Application of The Allen Morris Company to rezone properties from RSM (Small Lot Residential Mix) and R-85 (Residential-Medium Lot-85) District to HR-2 (High Density Residential-2) District to allow multi-family apartments, at 2490 North Druid Hills Road.

PETITION NO: N9. Z-21-1244535 2021-2116

STAFF ANALYSIS

Case No.: Z-21-1244535 **Agenda #:** N. 9

ZONING SITE PLAN

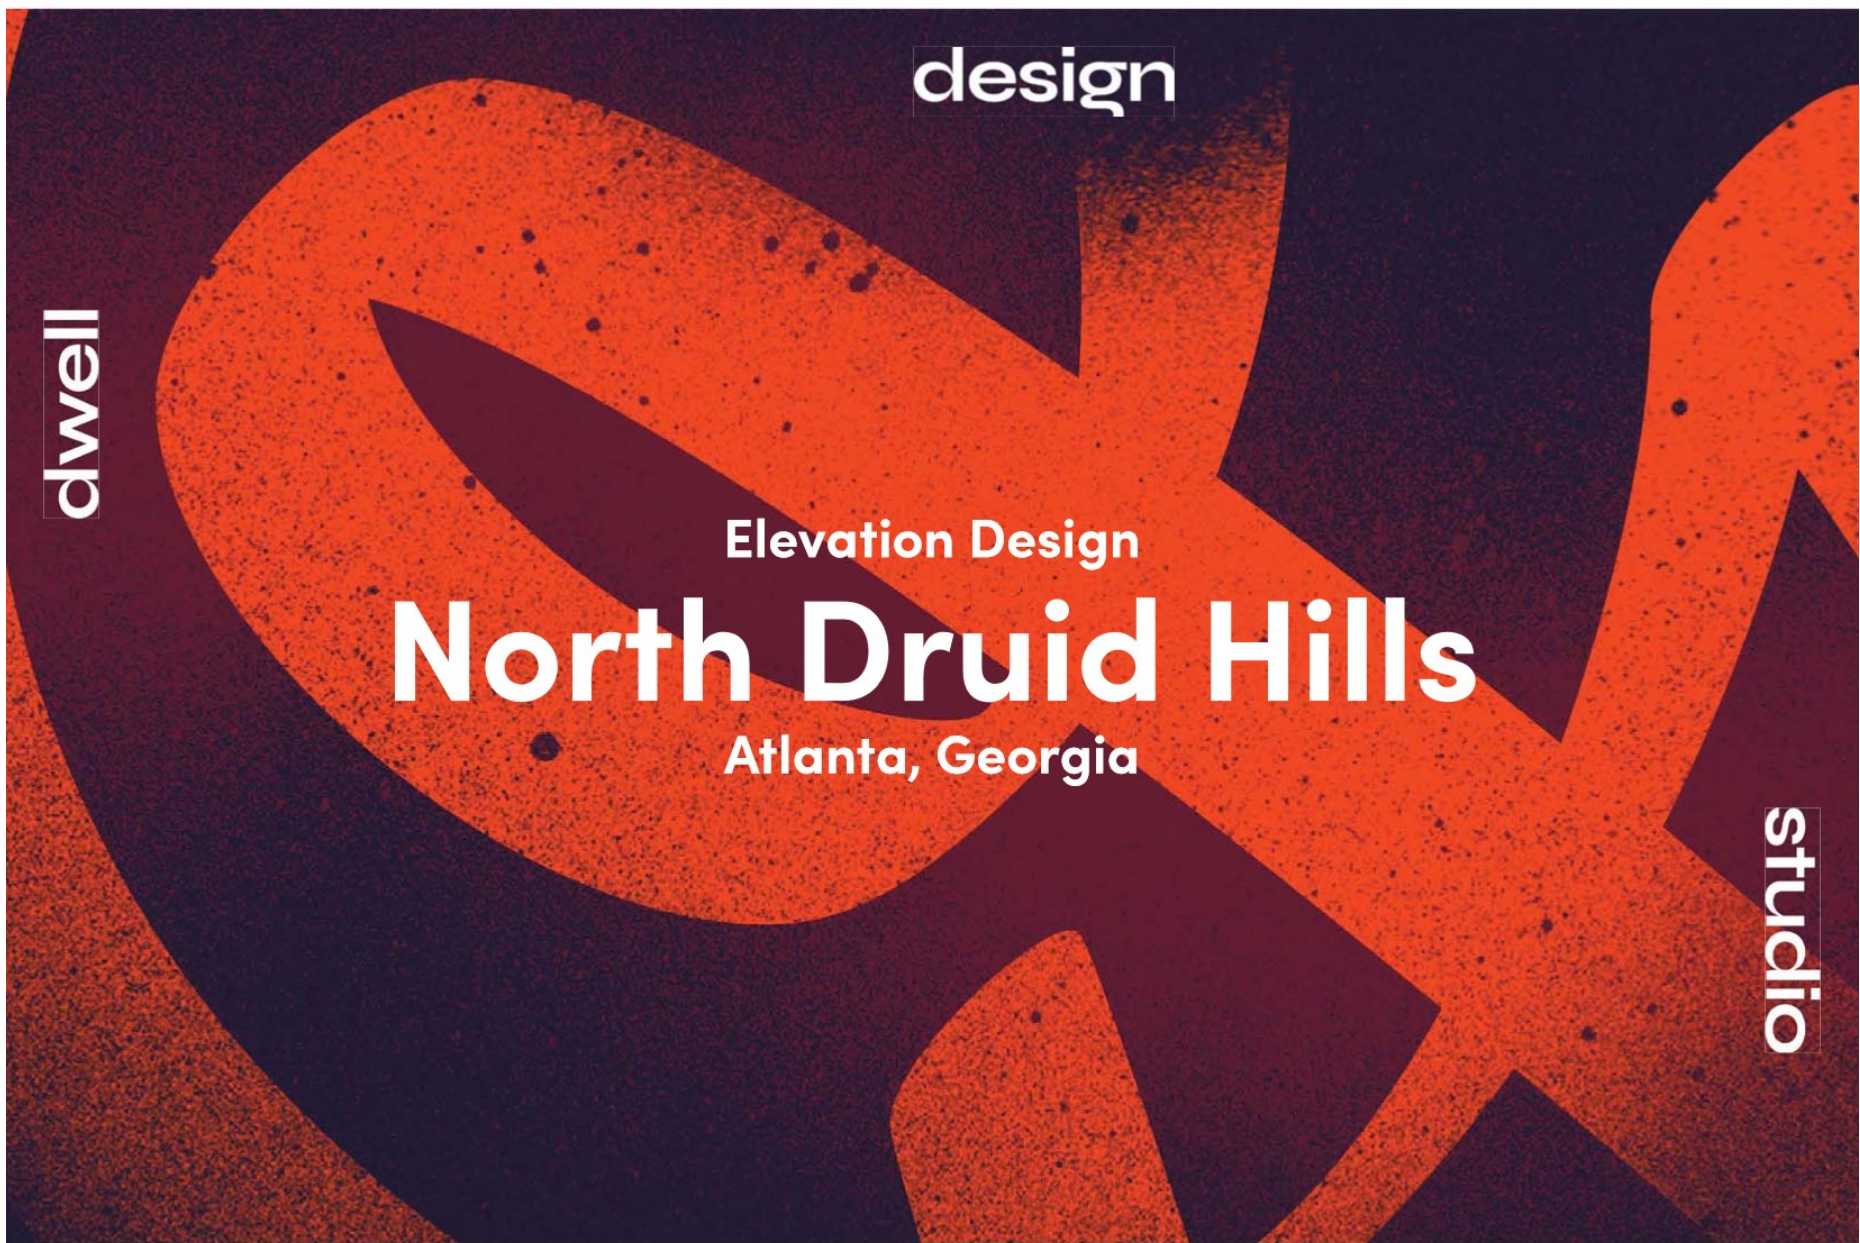
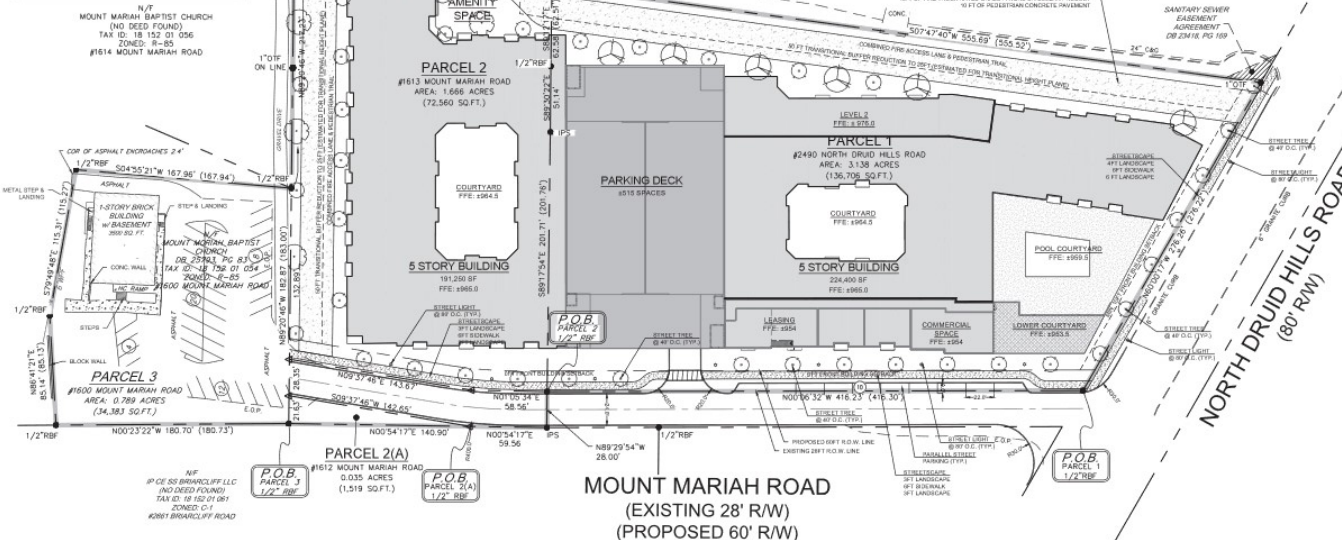
Proposed streetscaping on Mt. Mariah Road would be improved if the street trees were planted in the landscape strip between the sidewalk and the curb, to buffer pedestrians from traffic. As per Section 27-5.4.3(A)(2)(d)(i) of the DeKalb County Code, the landscape strip may be split to accommodate existing infrastructure, such as electric lines or light poles; however, such infrastructure doesn’t exist on Mt. Mariah Road. In contrast, on North Druid Hills Road, electric lines are planted in the existing landscape strip between the pavement and the sidewalk, impeding the realization of a desirable landscape strip along the property frontage.

STREETSCAPING - N. DRUID HILLS		Min. 4-ft. bike lane as per Section 27-14.190 of the DeKalb County Code	No bike lane shown on site plans.	A Planning Commission variance will be necessary.
MIN. STREETSCAPE DIMENSIONS – MT. MORIAH		6-ft. landscape strip and 5-ft. sidewalk on each side, light poles 100 ft. on center and street trees 30 ft. on center Landscape strip may be split to avoid interference with above-ground utilities.	3-ft. landscape strip, 6-ft. sidewalk, 3-ft. landscape strip; street trees 40' on center. Note: there are no existing above-ground utilities along Mt. Moriah Rd.	Variances will be necessary.

19:29:02 From Alan Pinsker : The site plan seems to show the building much closer to NDH than illustrated in the renderings. What is the intended set-back distance from NDH?
